PB# 75-33

VSH Realty, Inc.

787 Site Plan 78-33

Subject: V.S.H. Site Plans 75-32; 75-33; 75-34

SITE PLAN

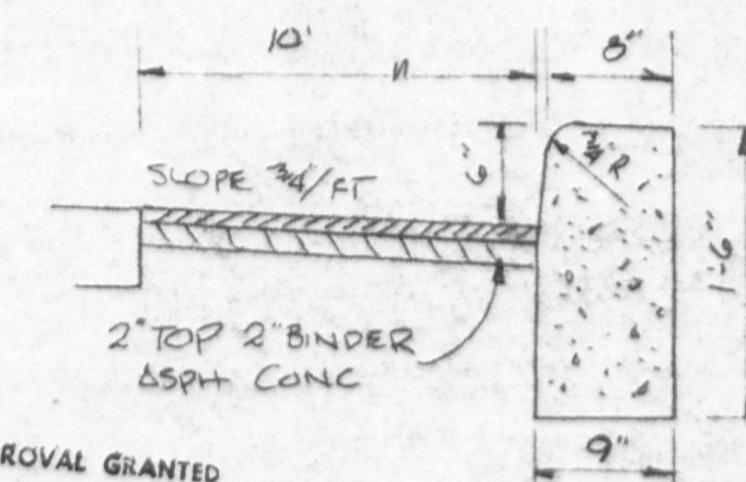
75-33 Rt. 94 and Union Avenue

Where will vents be located for underground tanks?

Ref. Section 16.23 Par. D 1 & 2 Pages 99 & 100

What is the protection above the underground tanks?

Ref. Section 16.23 Par. B Page 99

Where will the exits be located?
